Pilgrim Nuclear Power Station
600 Rocky Hill Road
Plymouth, MA 02360

August 6, 1999
ENGCLtr. 2.99.079

USI A-46 Supplementary Information

ATTACHMENT A
Information on use of GIP-2 Method A

Figure 1. Reactor Building (RB) elevation 23 Licensing Basis ISRS (solid) Compared to Licensing Basis Free Field Response Spectrum (dashed) and 1.5 times Bounding Spectrum (dotted)

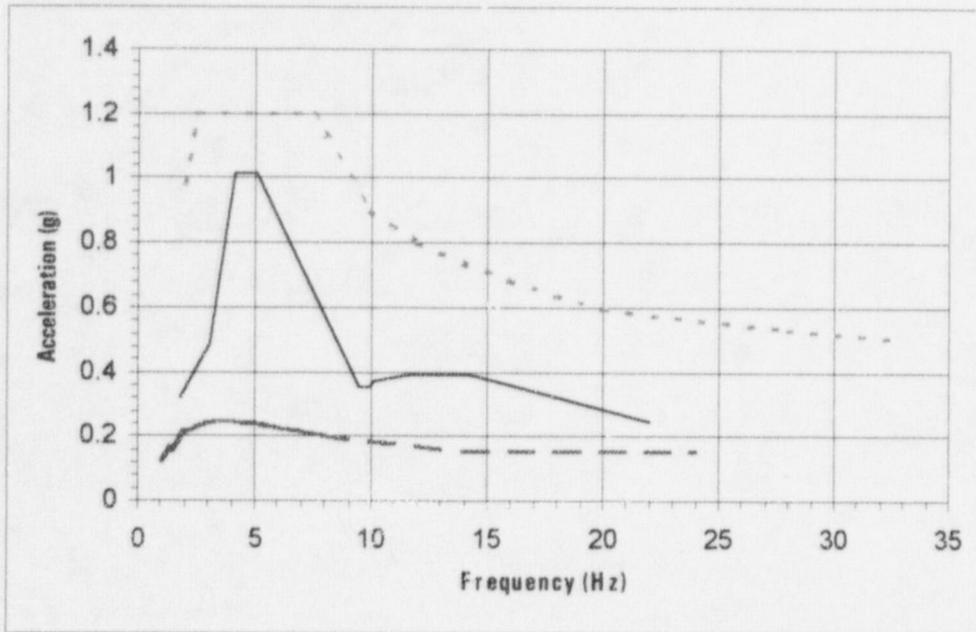
1. NRC Comment: In an April 1, 1999 telecon with NRC and Pilgrim Nuclear Power Station (PNPS) representatives on the use of GIP Method A at PNPS, the NRC noted the procedures used to evaluate the seismic adequacy of PNPS equipment are consistent with the GIP-2 guidelines and the NRC Supplemental Safety Evaluation Report No. 2 (SSER-2), with one exception. PNPS needs to show compliance with a key restriction of the GIP-2 methodology; i.e., the restriction that the amplification factor between the free field response spectra and the in-structure response spectra (ISRS) is not more than about 1.5. Without compliance with this restriction the application of GIP-2 Method A.1 is not appropriate. Since Method A.1 is used to evaluate the seismic adequacy of a portion of the safe shutdown equipment list (SSEL) components, the results of its A-46 effort must be justified.

Reactor Building (RB). The RB is an embedded, multi-story reinforced concrete shear wall structure up to the operating floor at elevation 117 feet. SSEL equipment in the RB is located below the operating floor elevation. The foundation consists of an 8-foot thick heavily reinforced concrete mat. The structure is founded on undisturbed soil approximately 42 feet above the bedrock elevation. The elevation of the top of the mat is (-)17.5 feet, which is approximately 40 feet below the site grade. For A-46 implementation, effective grade is specified to be the foundation elevation, so the highest floor using GIP Method A is elevation 23.

The 5% damped ISRS for elevation 23 compared to 1.5 times the Bounding Spectrum and the 5% damped PNPS licensing basis free field response spectrum is shown in Figure 1. It is seen that while the maximum amplification is about 4 at the primary structural frequency of about 4.5 Hz, the amplification is about 3 or less above 8 Hz.
